MIL-C-50652/12 (AR)
AMENDMENT 3
19 February 1993
SUPERSEDING
AMENDMENT 2
18 September 1974

MILITARY SPECIFICATION SHEET

CIRCUIT CARD ASSEMBLY: 10548086

FIGURE 1A △R OUTPUT SIGNALS

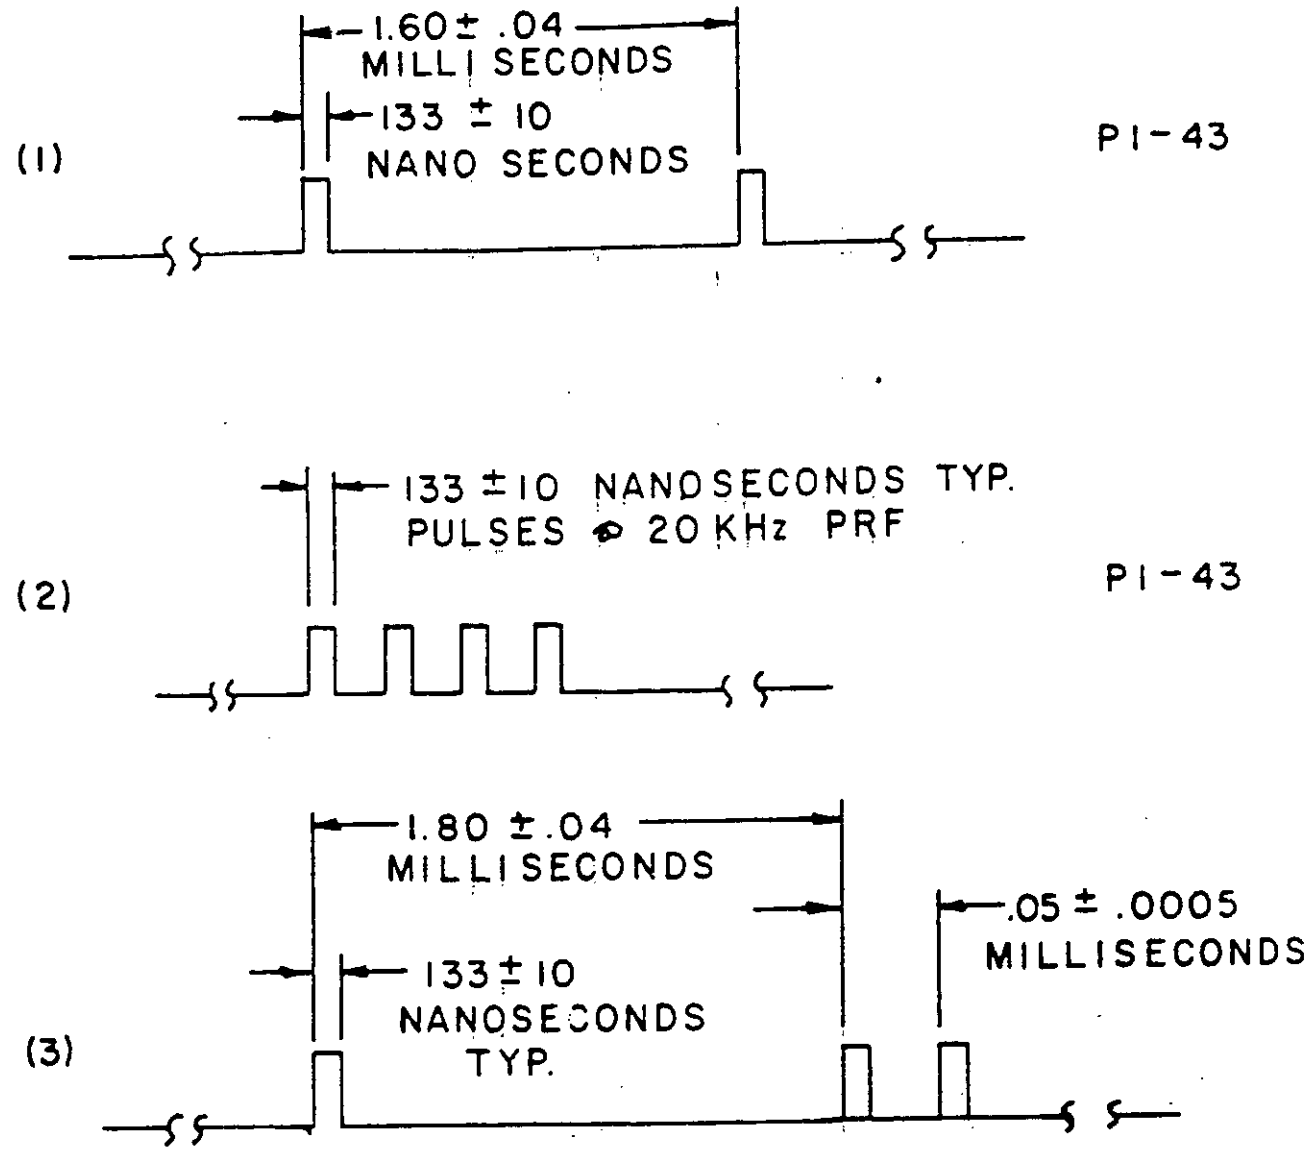
Add new Figure 1, as included Figure 1A.

NOTE: The display shown is generated by a period which alternates between 1.80 and 1.85 MSEC.

★ FIGURE 3. SIGNAL GENERATOR AND TIMING CIRCUIT.

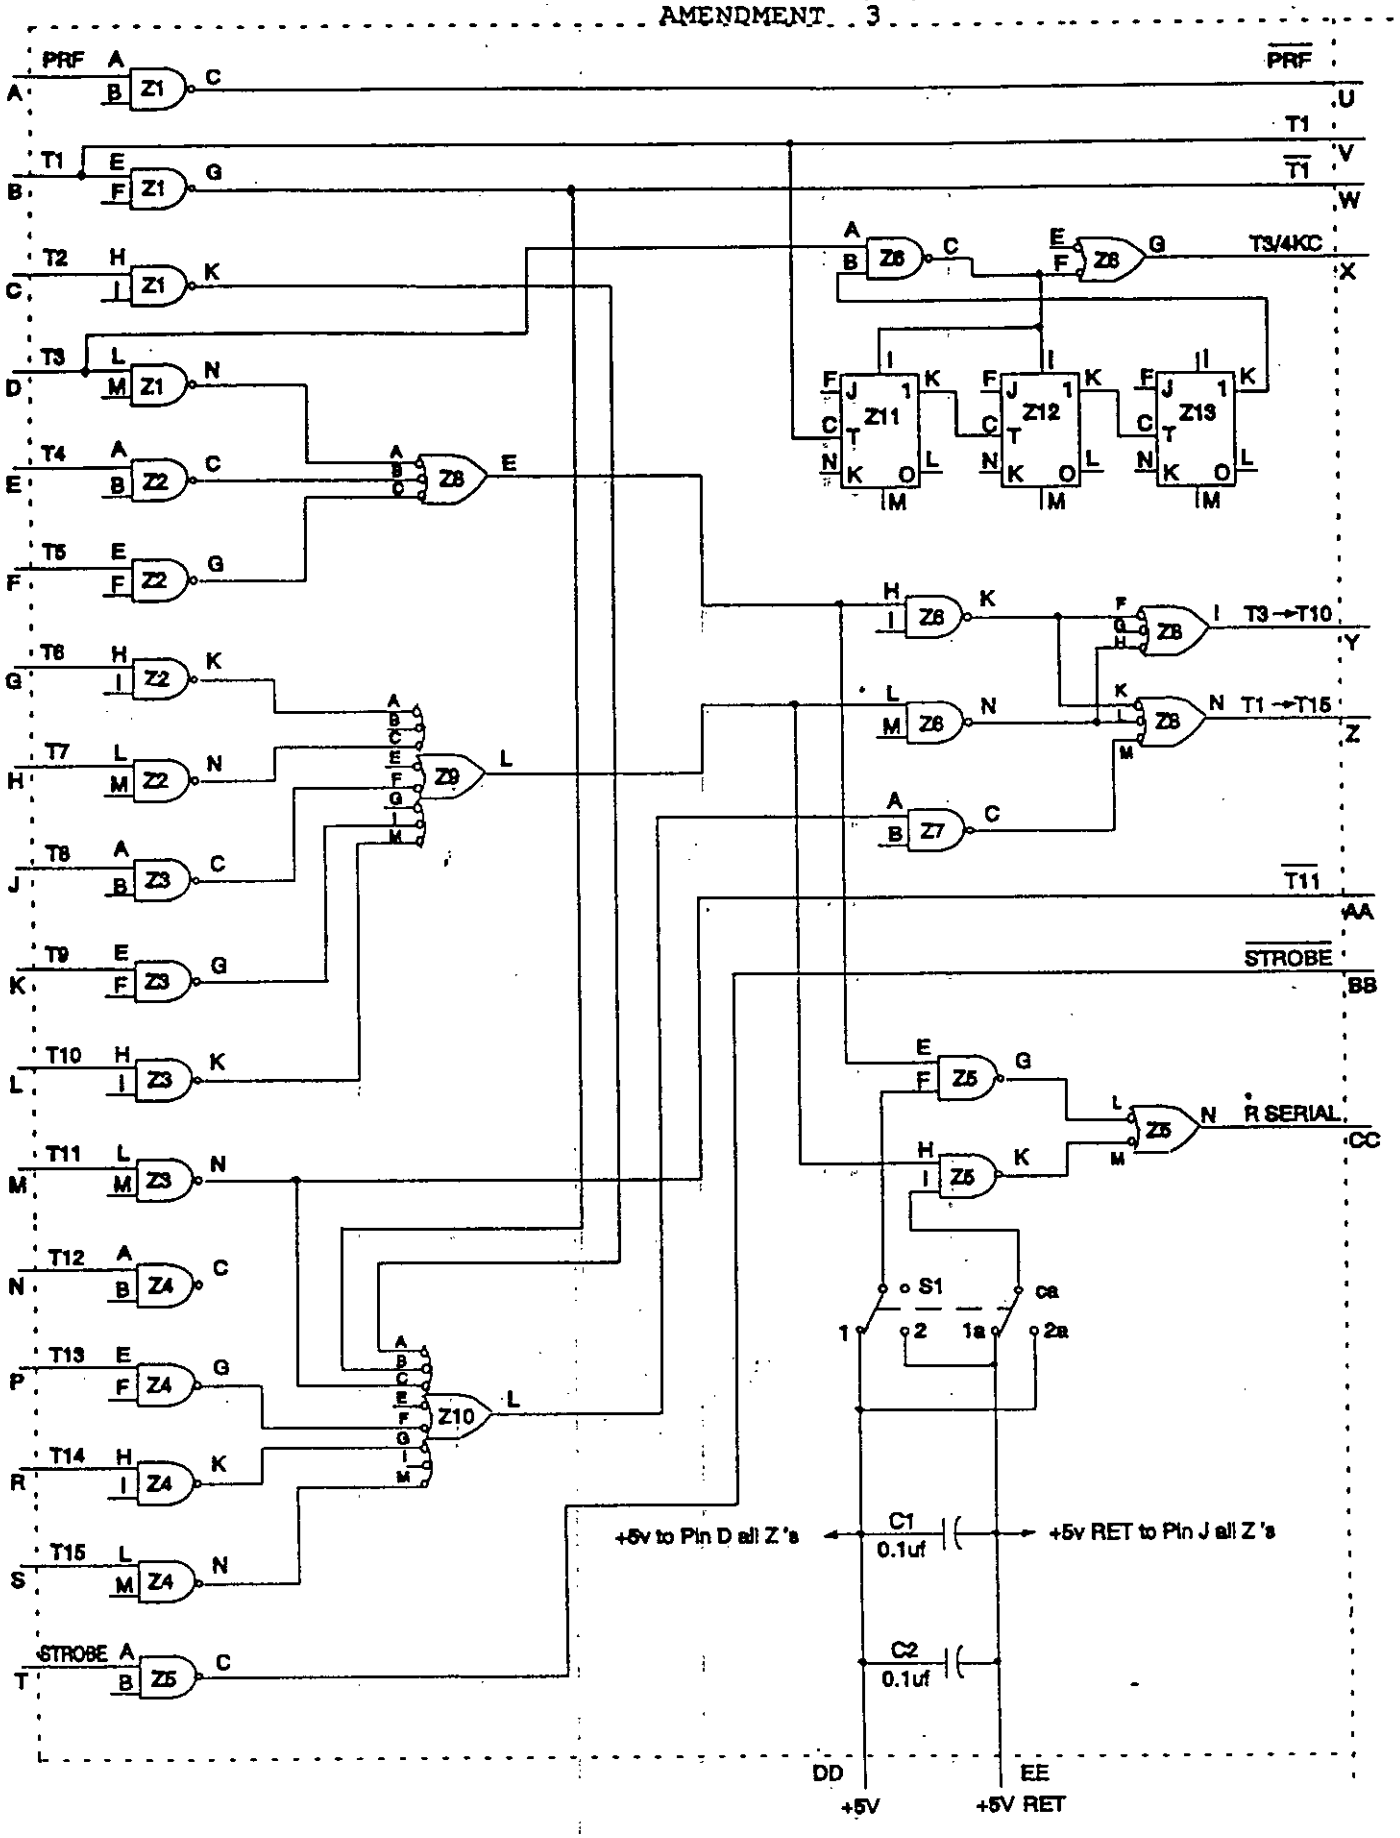
Figure 3: Delete in its entirety and substitute new Figure 3, included.
